# UNITED STATES PATENT AND TRADEMARK OFFICE

APPLICATION NO.	FILING DATE	FIRST NAMED INVENTOR	ATTORNEY DOCKET NO.	CONFIRMATION NO.
09/989,369	11/19/2001	Gregory Alan Whitlow	10541-273	1119
29074	7590	02/19/2004	EXAMINER	
BRINKS HOFFER GILSON & LIONE P.O. BOX 10395 CHICAGO, IL 60611			FORD, JOHN K	
			ART UNIT	PAPER NUMBER
			3753

## Office Action Summary

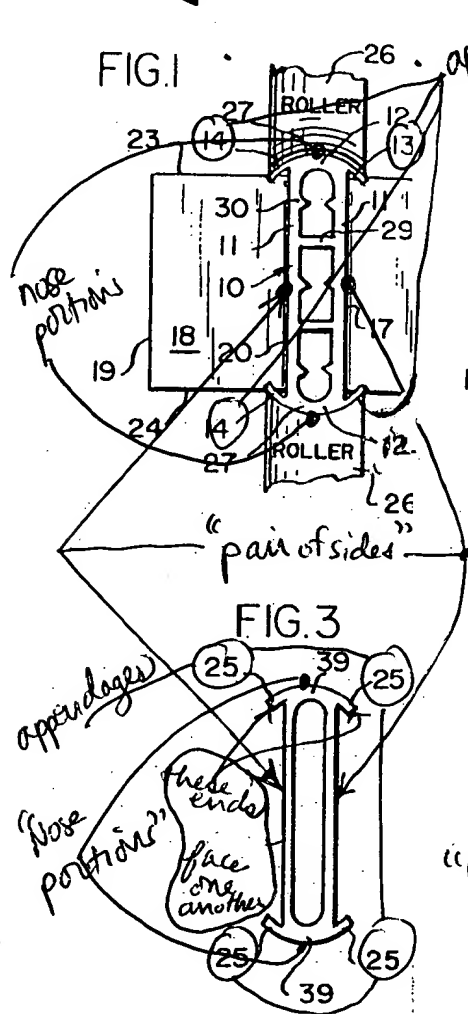
Claims 2 – 4, 8-11, 16-18, 25 – 28 and 32-35 are rejected under 35 U.S.C. 102(b) as being anticipated by Awe et al. (USP 3,731,732)

Figures 1 and 3 show a tube, which satisfies the claim limitations. Curved portions 13 in Figure 1 face each other, as do curved portions 14. Similarly in Figure 1, each of curved portions 13 and 14 at each edge 12 "face" each other when a horizontal line is drawn across the diagram of Figure 1 at the terminal edge. The claim can be read on the reference in at least two ways depending on whether sides 11 are

The two distinct interpretations are shown below using applicant's claim language:

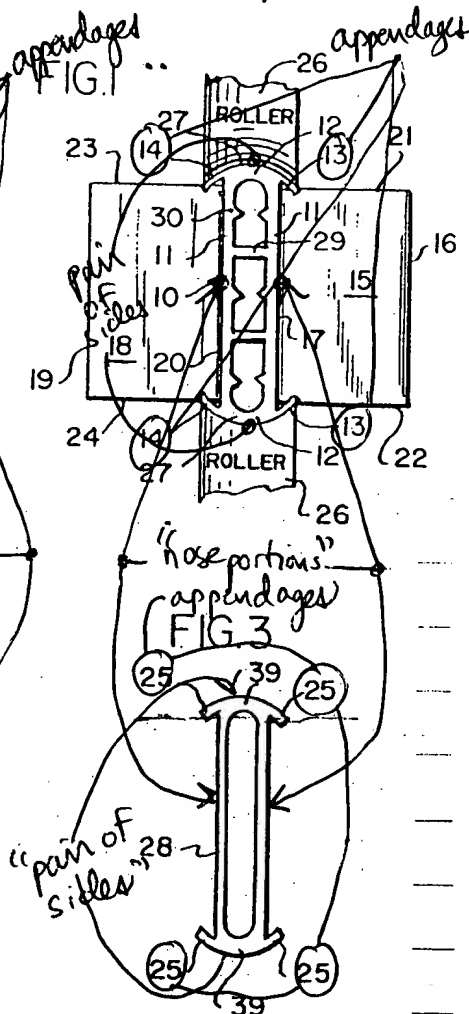
considered to be the claimed "ends" or whether edges 12 are considered to be the claimed "ends". The Examiner relies on both interpretations to maintain this rejection.

Interpretation I

Interpretation II

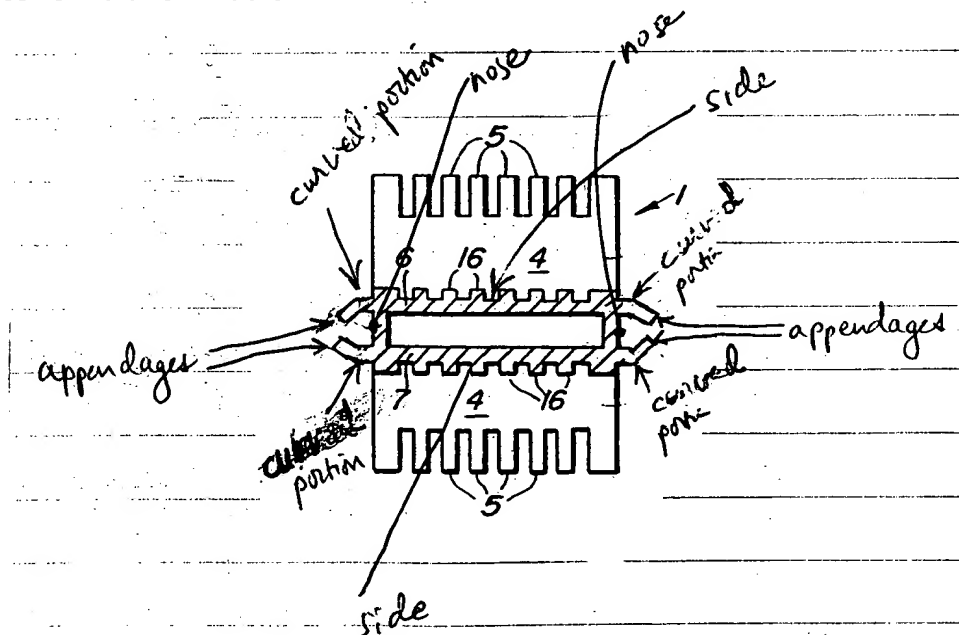
Claims 2 – 4, 8-11, 16-18, 25-28 and 32-35 are rejected under 35 U.S.C. 103(a) as being unpatentable over the combined teachings of O'Connor and Yoshii et al. (5,653,283).

O'Connor shows straight "appendages" at each end of the tube which project outwardly parallel to major cross-section axis of the tube. To have curved each of these projections in O'Connor towards one another as taught by Yoshii Figure 1 at "4f" would have been obvious to improve air flow as discussed in col. 5, lines 5-10, by making the transition less abrupt than a blunt end would be. Such an improved curving of airflow would advantageously reduce the airside pressure drop through the heat exchanger. The modification is shown below:

Regarding claim 8, O'Connor shows appendages at each end of the tube (a total of four) and Yoshii explicitly teaches identical treatment of the inlet and outlet faces in col. 4, lines 32-34. Such treatment advantageously permits the heat exchanger to be installed in either orientation without airflow problems occurring due to an asymmetrical construction of the appendages.

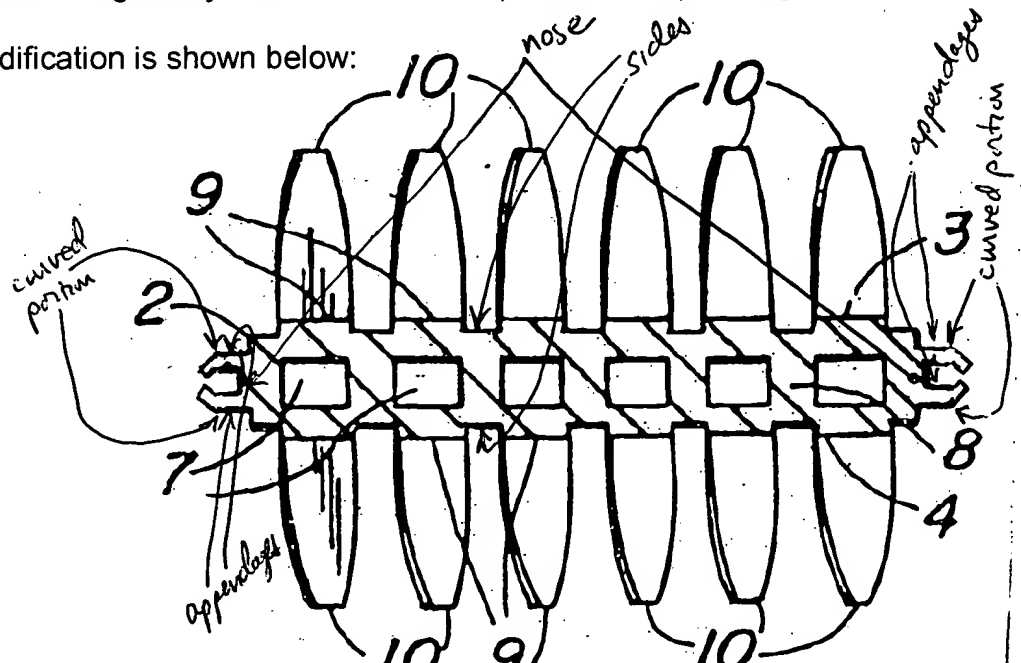
Claims 2 – 4, 8 – 11, 16 – 18, 25 – 28 and 32 – 35 are rejected under 35 U.S.C. 103(a) as being unpatentable over the combined teachings of DT'069 and Yoshii et al. (5,653,283).

DT'069 shows straight "appendages" at each end of the tube which project outwardly parallel to major cross-sectional axis of the tube. To have curved each of these projections in DT'069 towards one another as taught by Yoshii Figure 1 at "4f" would have been obvious to improve air flow as discussed in col. 5, lines 5-10, by making the transition less abrupt than a blunt end would be. Such an improved curving of the airflow would advantageously reduce the air-side pressure drop through the heat exchanger. The modification is shown below:

Regarding claim 8, DT'069 shows appendages at each end of the tube (a total of four) and Yoshii explicitly teaches identical treatment of the inlet and outlet faces in col. 4, lines 32-34. Such treatment advantageously permits the heat exchanger to be installed in either orientation without airflow problems occurring due to an asymmetrical construction of the appendages.

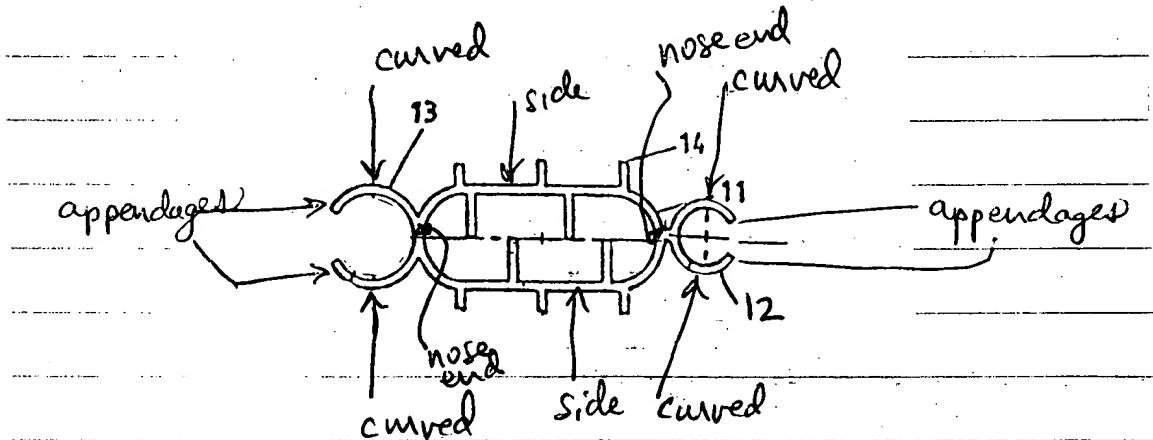
See figs 3 – 4a and page 5 lines 5 – 21, noting flat or round tubes 1 having semicircular projections 12, 13 at the ends of the tubes. Whilst there is no disclosure of a condenser, it is considered obvious that as it is for heat transfer, the tubes could be used in a vehicle condenser, residential condenser or a radiator oil cooler.

Note in Figure 3 that there are elements 12 and 13 at each end of tube 11 (element 12 was omitted at the right hand of tube 11 in Figure 3a). The correct showing, in the Examiner's opinion, is shown below.

Contrary to applicant's remarks there is no disclosure that elements 12 and 13 are attached to each other. They are "fit" together, but they are not attached. Moreover the two appendages forming element 13 are only attached to one "nose" end of the tube and the two appendages forming element 12 are only attached to the opposite nose end of the tube.

Moreover, it would have been obvious to use the tube illustrated by the Examiner even on the boundary of the system shown in Figure 3, because to do otherwise would require extruding different shaped tubes for the peripheral edges of the heat exchanger versus those in the central region, a costly modification. Finally, to have used the same tube in a heat exchanger comprising only a single row of tubes would have been obvious for a heat transfer situation not requiring a multiple row of tubes (e.g. power dissipation). Single row heat exchangers are well known to those ordinary skill and official notice is taken of them. If counsel challenges the subject of official notice, see USPN 5,251,692, of record.
